Docket Item # 3  
BAR CASE #2010-0373

BAR Meeting  
March 16, 2011

**ISSUE:** Alterations—Roof Replacement

**LOCATION:** 917 Prince Street

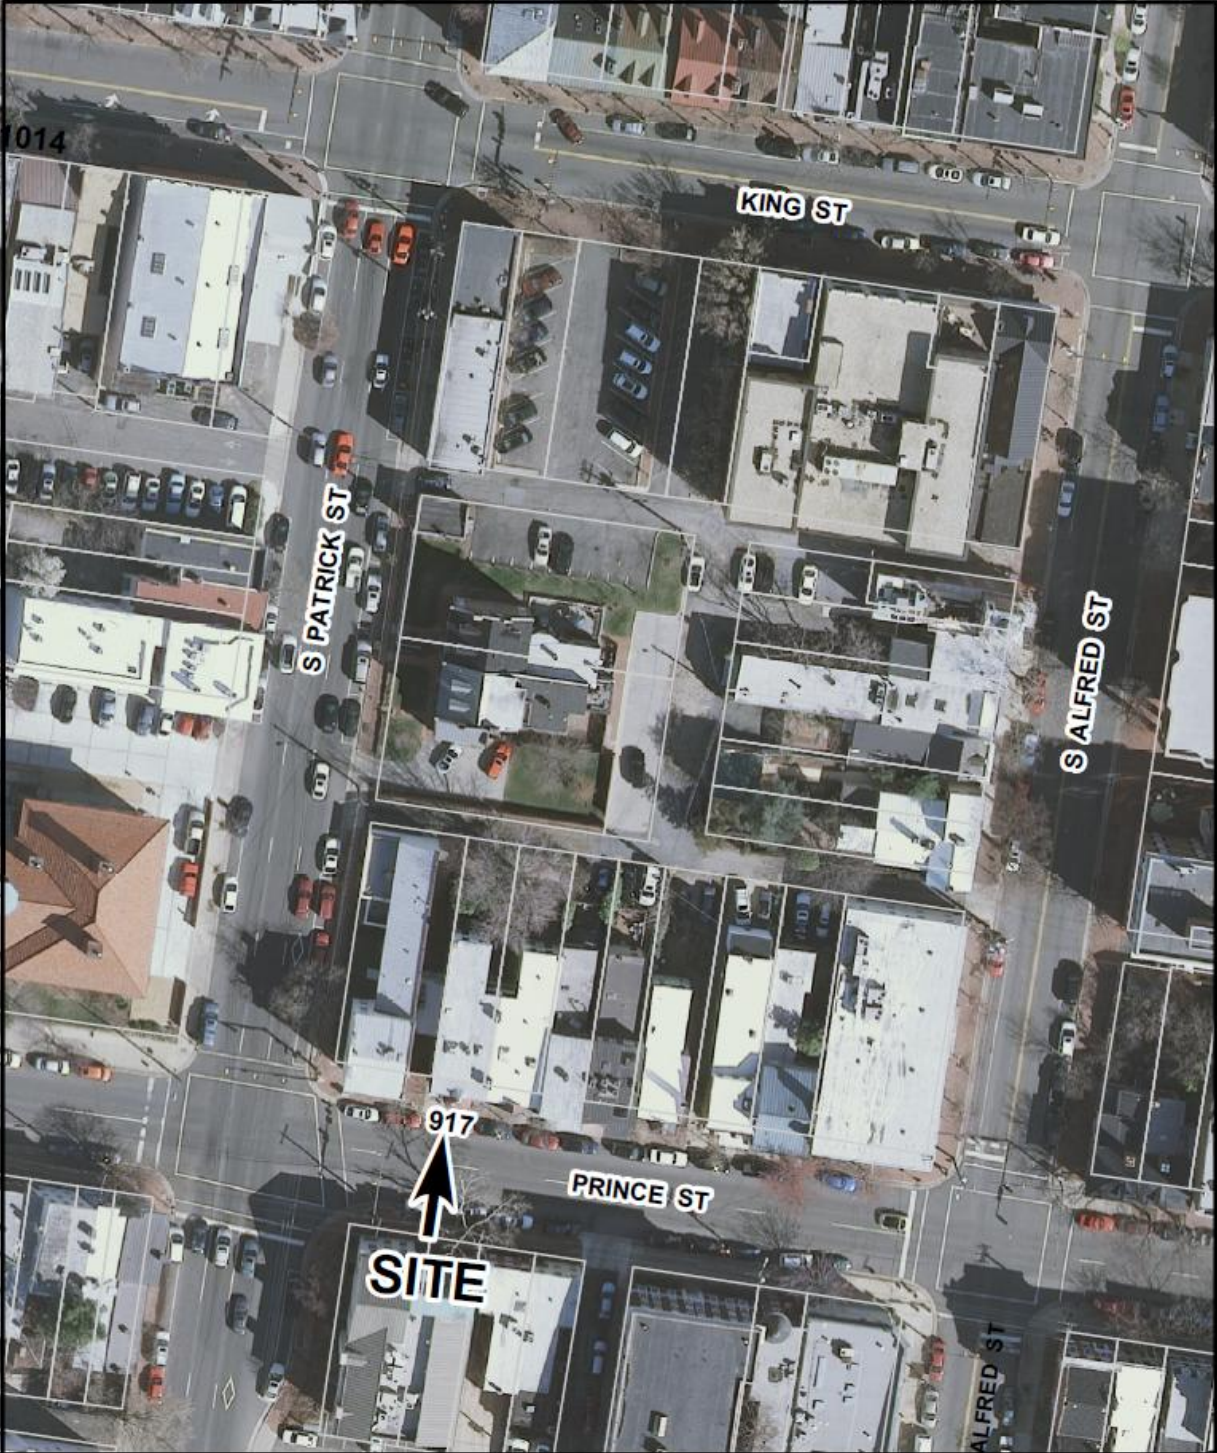
Should the Board find that replacement with an alternate roof material is appropriate, Staff advises that the replacement material be a shingle form so that the visual appearance and texture is more closely approximated. As stated above, clay tiles, on various roof forms including turrets and towers, are a key identifying feature of the Richardsonian Romanesque style that adds decoration and texture to this visually prominent architectural feature. In this instance, the use of barrel tiles on the mansard portion creates a vertical emphasis that contrasts with the heavily textured, horizontal focus of the tiles on the turret. The use of a standing seam metal would simplify the surface texture and result in the loss of this intentional contrast and depth on this curved form. However, a shingle in an alternate material, could more closely match the original “design...texture and other visual qualities and...utilize the same materials and installation method.” The *Roof Materials Policy* also recommends matching the color—therefore, a red slate shingle, painted to match the existing tiles, is preferred to a metal standing seam or a metal shingle. *However, a red slate tile would not have the distinctive decorative knob that results in a fluted edge that the existing tiles possess.*

However, if the Board finds that a replacement material is appropriate, Staff recommends that the replacement material match the original as closely as possible in “design, color, texture and other visual qualities” and believes that the field fabricated red slate is the best alternative to the custom fabricated red clay tile for this small area *though Staff continues to have reservations about the visual qualities of this substitute material.*

**STAFF RECOMMENDATION:** Staff recommends denial of the application in accordance with the BAR Roof Materials Policy (adopted 10/20/2010). However, if the Board finds that a substitute material is appropriate, that it be a shingle matching the form, color, design, texture and other visual qualities of the existing tile roof as closely as possible.
